# Access Compliance Report

## Public Rights-of-Way

### (Pedestrian Signals)

| ADA ID: ED09FFAB66E4                    | Signal Type: One Push Button-APS | Overall Compliance: No                  | Severity Score: BTN 1: N/A BTN 2: N/A No BTN: N/A |

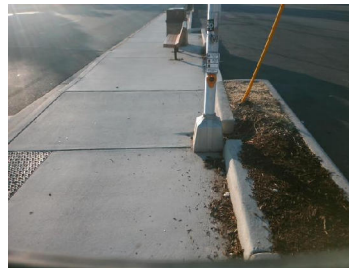
Surveyor Notes: TEXT HT 3/8

PROW/ADA: R410.6, TMUTCD 4e.08, R404.2, R404.3, R406.2, R209.1, MUTCD 4e.10

Possible Solutions: Replace Signal Push Button With APS Button on New Post. Remove & Replace Sign.
